Access Compliance Report

Public Rights-of-Way

(Curb Ramps)

Intersection ID: 27461	Main Street: BRUSH_HOLLOW_RD	Cross Street: FAWN_HILL_RD	Location: S
ADA ID: B5595A1820A8	Ramp Type: BlendTrans1	Initial Pass/Fail: Fail	Overall Compliance: No
Severity Score: 21.25			
Codes/Mitigation Info/Possible Solution		Field Measurements/Component Compliance

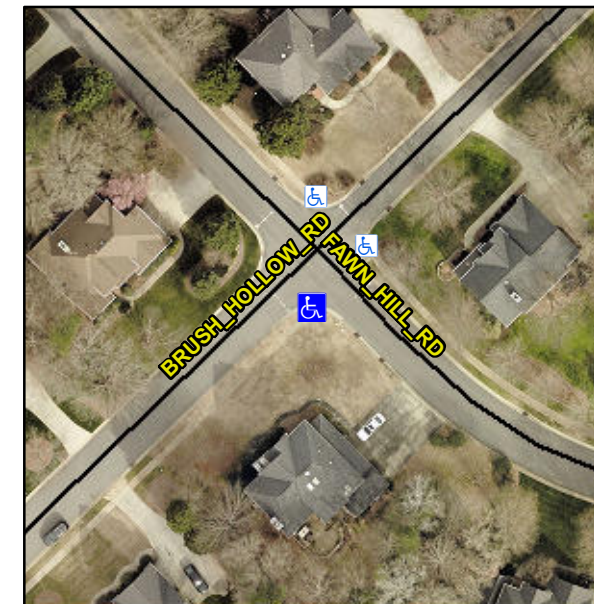
Not Found, R304.5.1, R304.5.3

Compliance	Description	Data	Compliance	Description	Data
N/A	Ramp Length (in)	48.5	Yes	BlendTrans Slope (%)	4.4
No	Ramp Width (in)	41.5	No	BlendTrans XSlope (%)	5.4
N/A	Flare Type LT	N/A	N/A	Flare Type RT	N/A
N/A	Flare Slope LT (%)	N/A	N/A	Flare Slope RT (%)	N/A
N/A	Flare Traversable LT?	N/A	N/A	Flare Traversable RT?	N/A
N/A	Landing Length (in)	N/A	N/A	DWS Provided?	N/A
N/A	Landing Width (in)	N/A	N/A	DWS Contrast?	N/A
N/A	Landing Slope (%)	N/A	N/A	DWS Length (in)	N/A
N/A	Landing X Slope (%)	N/A	N/A	DWS Full Width?	N/A
N/A	Landing Curb? (Y/N)	N/A	N/A	DWS Offset (in)	N/A
N/A	Shared Landing?	N/A			
N/A	Gutter Ponding?	N/A	N/A	Gutter Slope (%)	N/A
N/A	Gutter Lip Ht (in)	N/A	N/A	Gutter X Slope (%)	N/A
N/A	Painted X Walk1?	No	N/A	Painted X Walk2?	N/A
	X Walk 1 Direction	To NE		X Walk 2 Direction	N/A
	X Walk 1 Width (in)	N/A		X Walk 2 Width (in)	N/A
	X Walk 1 Slope (%)	5.2		X Walk 2 Slope (%)	N/A
	X Walk 1 X Slope (%)	1.5		X Walk 2 X Slope (%)	N/A

N/A	Ramp inside XWalk1?	N/A	N/A	Ramp inside XWalk2?	N/A
	Road Slope (%)	1.5		Clear Space?	N/A
	Road X Slope (%)	5.2	N/A	Clear Space to XWalk (in)	N/A
N/A	Any Obstructions?	N/A	N/A	Storm Grate/Utility Hazard?	N/A
	Obstruction Type			Storm Grate/Utility Type	
		N/A			N/A
			Yes	Surface Condition? (G/P)	Good
			No	Curb Slope (%)	12.3

Remove & Replace Curb Ramp With Two New Directional Ramps or Equivalent.
